# UNITED STATES PATENT AND TRADEMARK OFFICE

APPLICATION NO.	FILING DATE	FIRST NAMED INVENTOR	ATTORNEY DOCKET NO.	CONFIRMATION NO.
10/822,064	04/08/2004	Neal Meyer	200312670-1	2065
<div>22879                      7590                      11/29/2007 HEWLETT PACKARD COMPANY P O BOX 272400, 3404 E. HARMONY ROAD INTELLECTUAL PROPERTY ADMINISTRATION FORT COLLINS, CO 80527-2400</div>				
			<div>EXAMINER CHANG, RICK KILTAE</div>	
			<div>ART UNIT 3726</div>	<div>PAPER NUMBER</div>
			<div>MAIL DATE 11/29/2007</div>	<div>DELIVERY MODE PAPER</div>

# Office Action Summary

Sheet 28 of 32

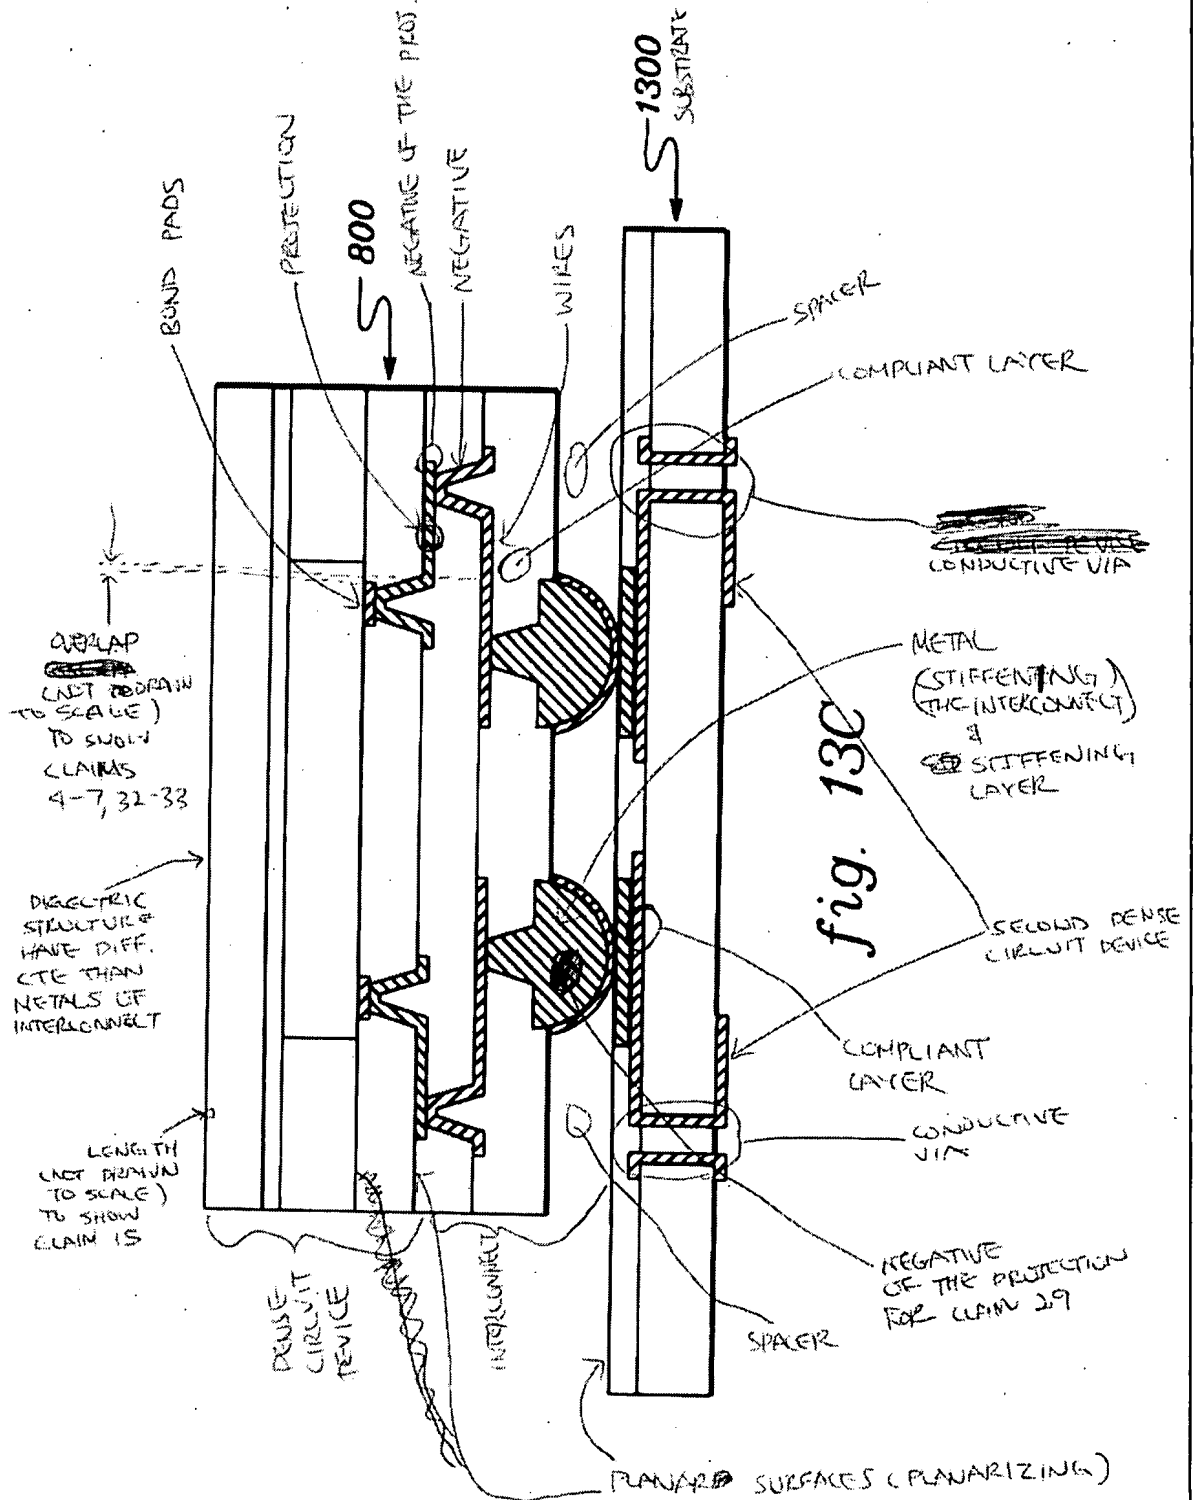
8. Claims 1-7 and 15-17 are rejected under 35 U.S.C. 102(e) as being anticipated by Eichelberger et al (US 6,555,908).

Eichelberger discloses as follows:

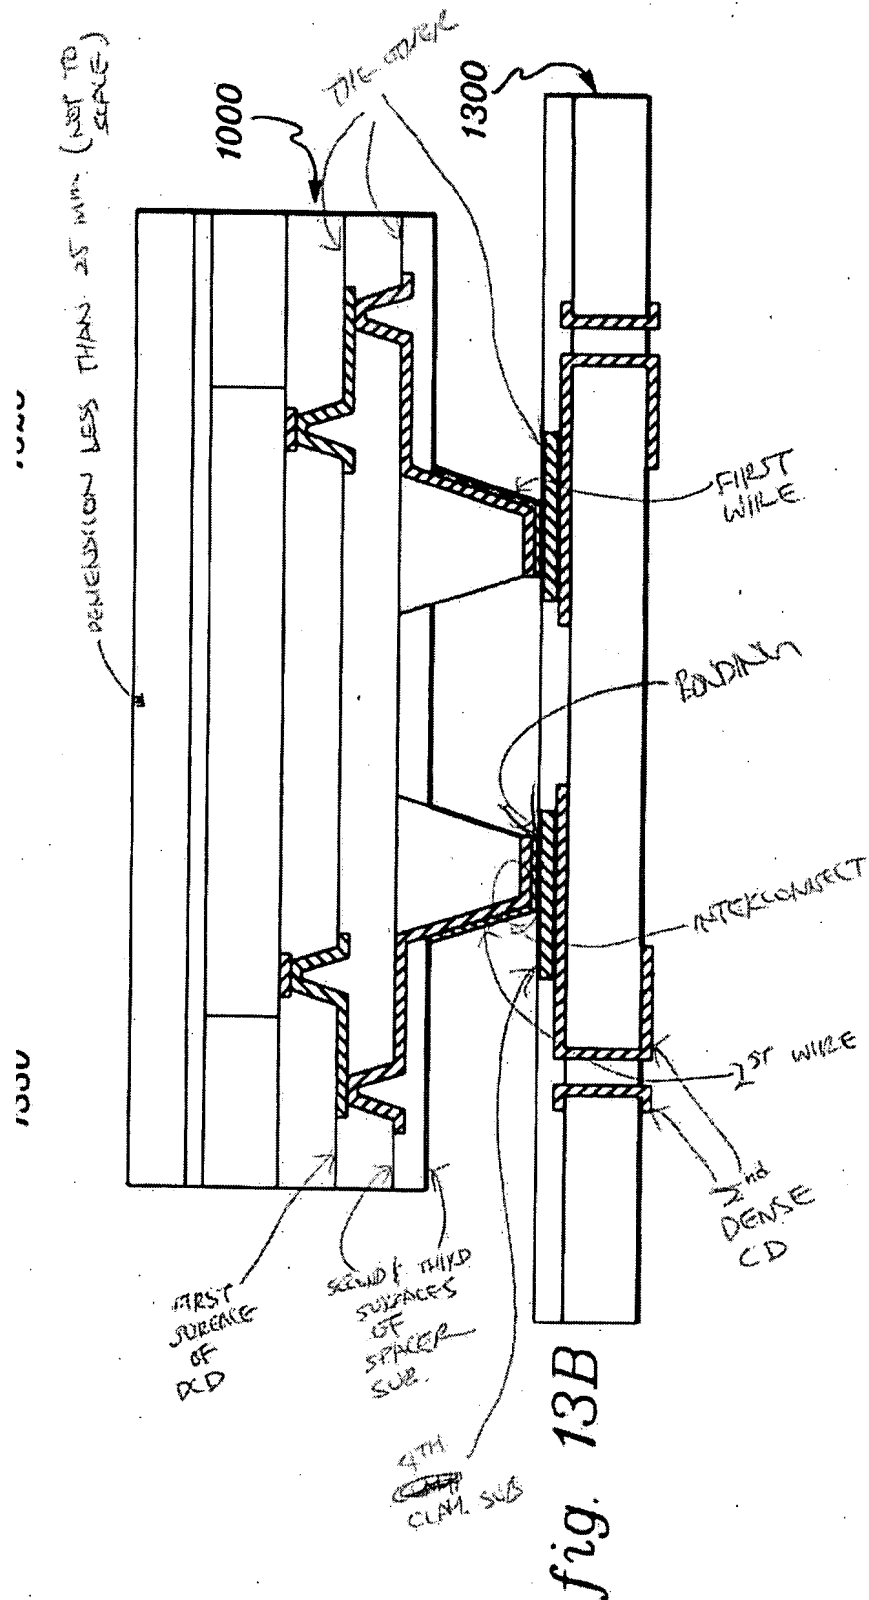
12. Claims 44-48 are rejected under 35 U.S.C. 103(a) as being unpatentable over Eichelberger et al (US 6,555,908) in view of Tong et al (US 6,962,835).

Eichelberger discloses as follows:

ALL THE SURFACES HAVE ~~PERFORATED~~ PLANAR SURFACES (PLANARIZING)

FIG 2

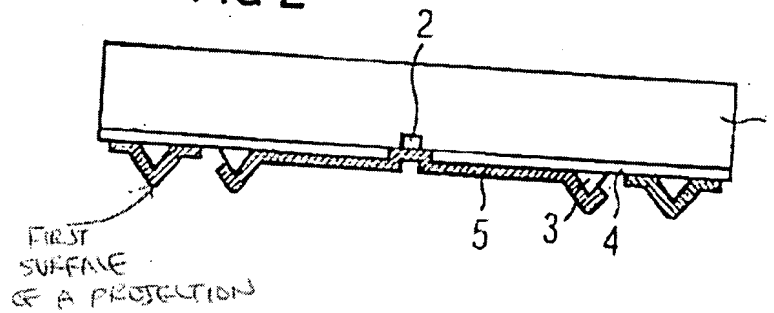
13. Claims 49-55 are rejected under 35 U.S.C. 103(a) as being unpatentable over Hedler et al (US 6936928) in view of Tong et al (US 6,962,835).

Hedler discloses as follows:
